Alameda County
Environmental Health

March 28, 2011

**Subj: Workplan Addendum to Delineate Extent of Free Product
at 3820 Manila Avenue, Oakland, CA**

Figure 1: Locations of Proposed Soil Borings

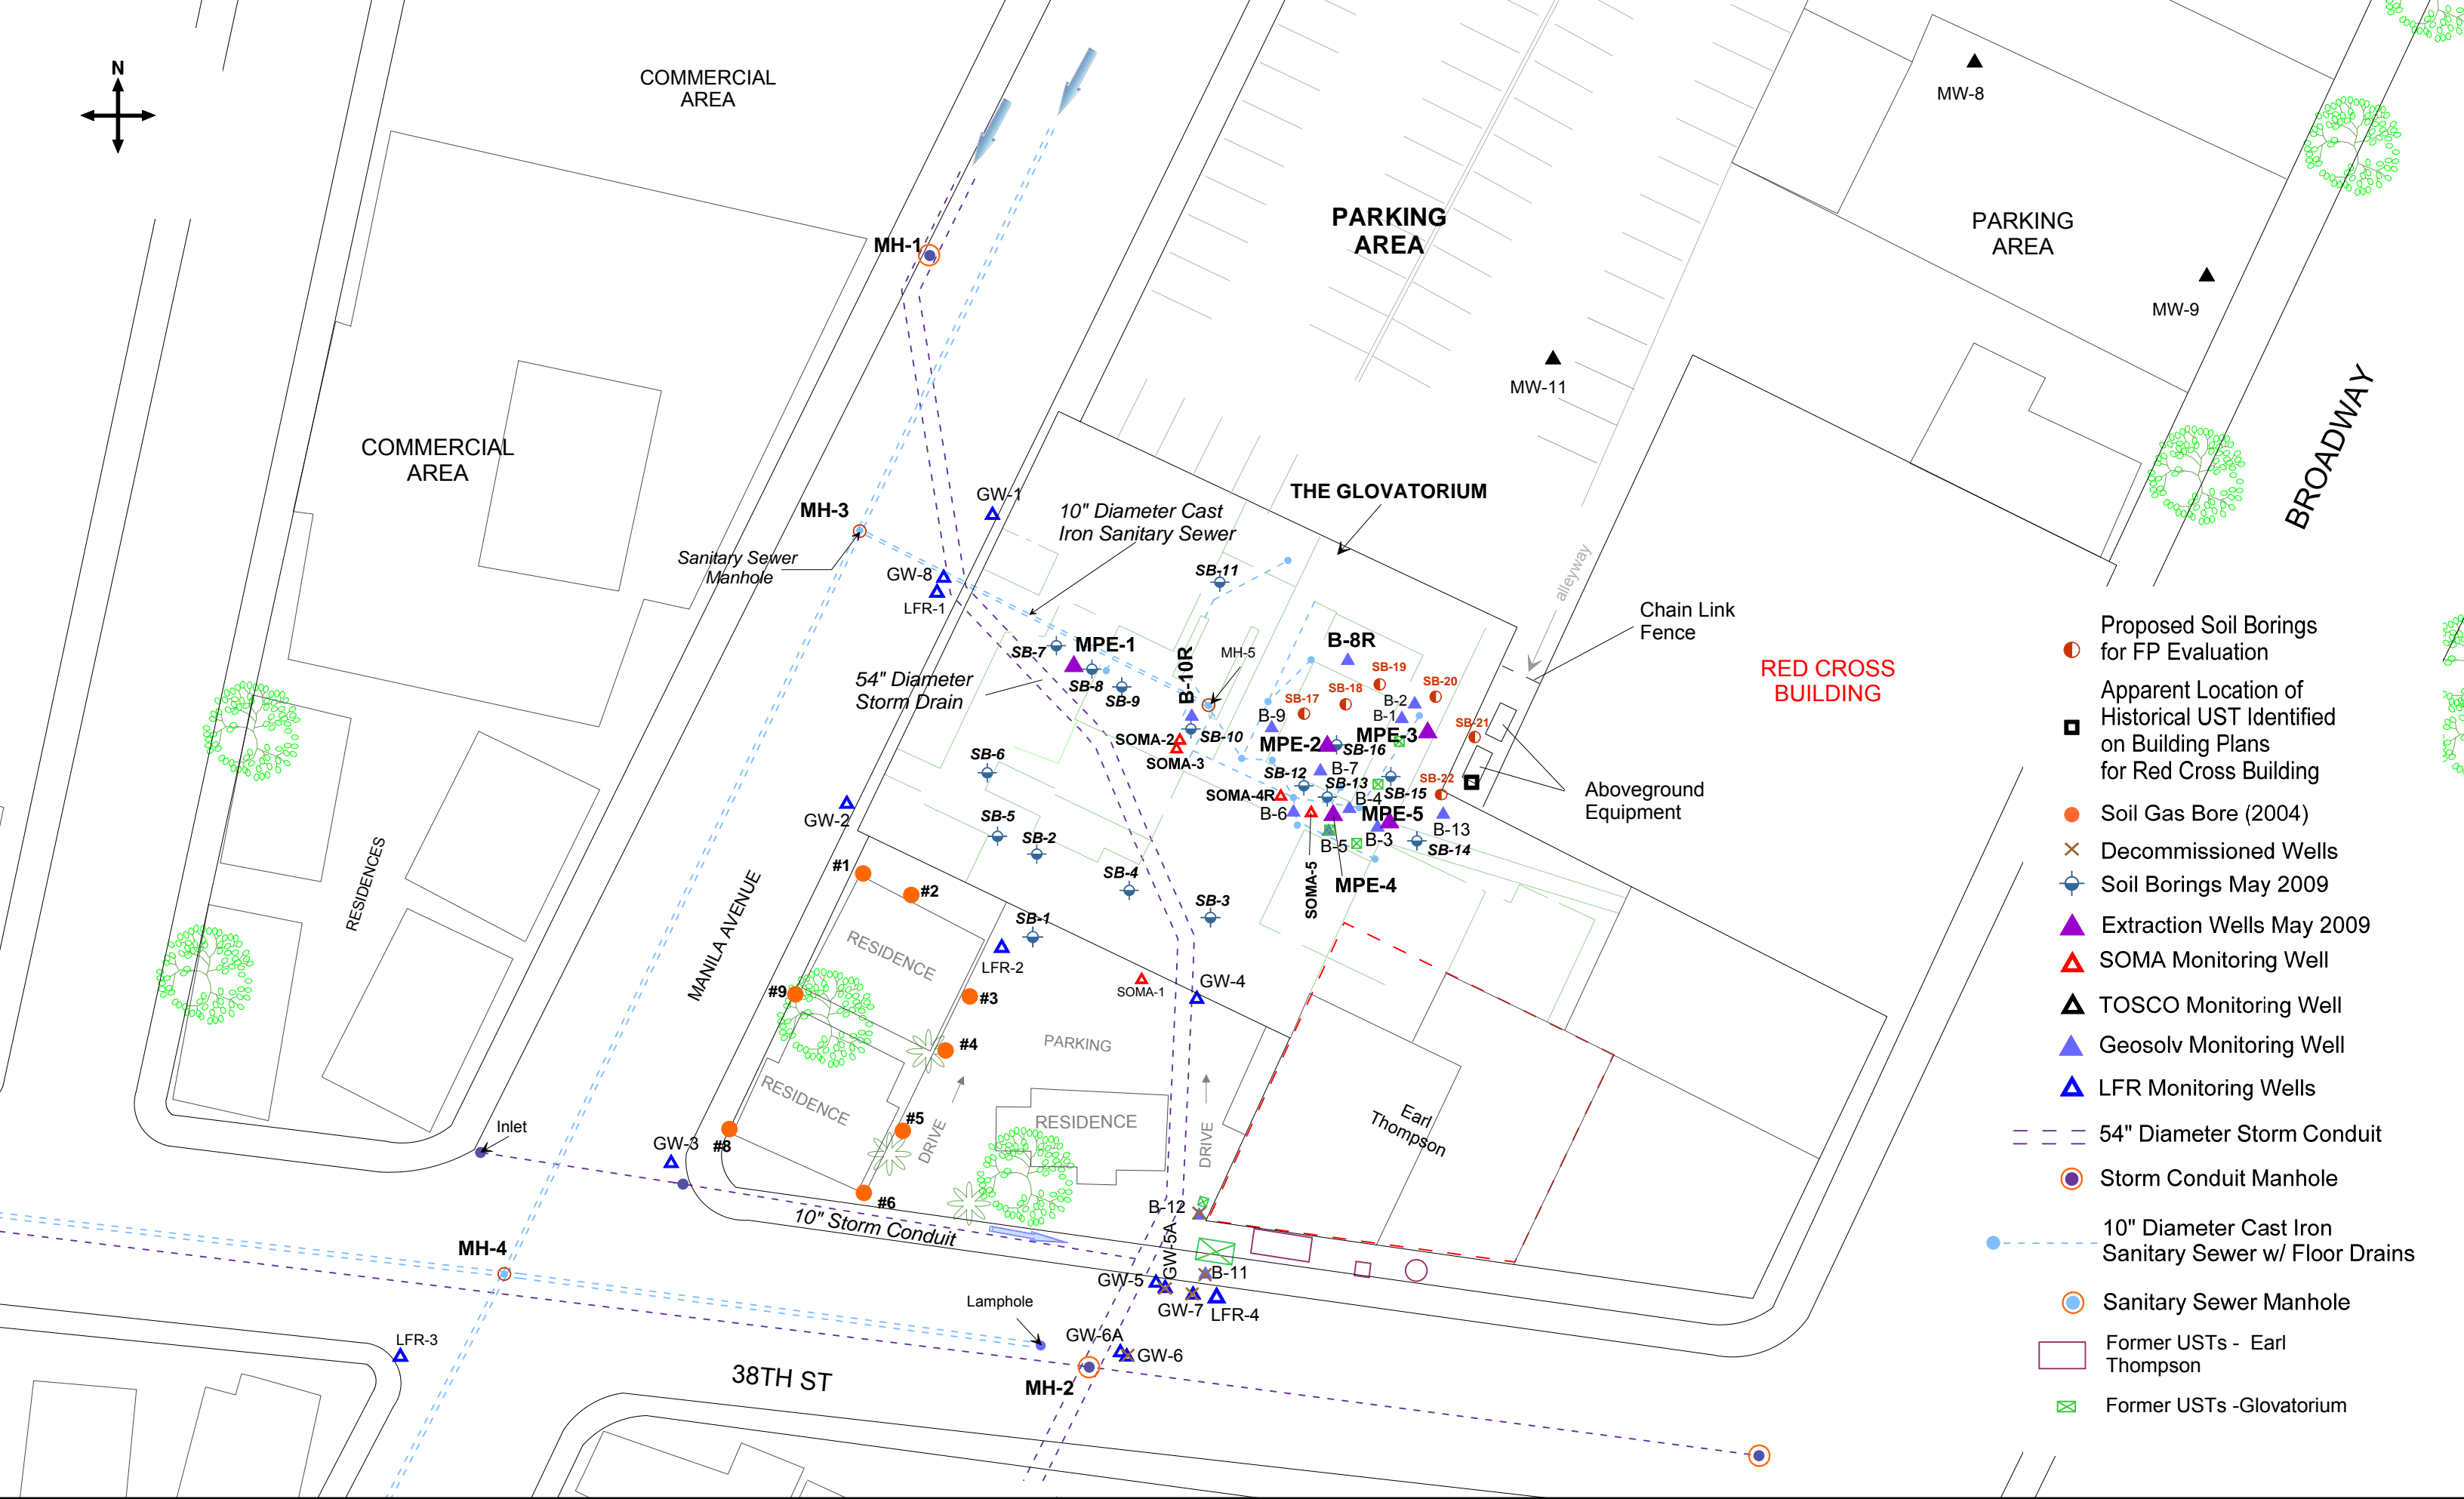
SOMA had planned to advance all proposed borings (SB-17 through SB-22) utilizing a limited direct push technology (DPT) rig. Concrete surface will be required for the smallest DPT equipment to be bolted down during boring advancement. To fully define the extent of FP, each proposed boring will be advanced to approximately 20 feet bgs (25 feet bgs where appropriate, due to surface elevation changes). On February 24, 2011, SOMA visited the Red Cross building and conducted a site reconnaissance. During this evaluation, two pieces of equipment were observed adjacent to the Red Cross building in the area of proposed borings (SB-21 and SB-22). During site reconnaissance it was observed that concrete surface in the area of proposed boring SB-21 is likely

located too close to the aforementioned equipment to be suitable for anchoring. Due to this access limitation, some borings will be advanced utilizing the limited DPT rig; where lack of access precludes use of DPT, hand augering to total depth will be employed. Some borings were moved slightly to compensate for the anticipated site limitations. During hand augering, SOMA will utilize recovered soil cuttings to evaluate subsurface lithology; integrity of the proposed subsurface sampling or free product observations will not be impacted. All necessary general field and quality control procedures (documented in the approved workplan) applicable to subsurface sampling will be utilized. Attachment 1 catalogs photographs that show area near the proposed drilling locations. Figure 1 shows the proposed drilling locations.
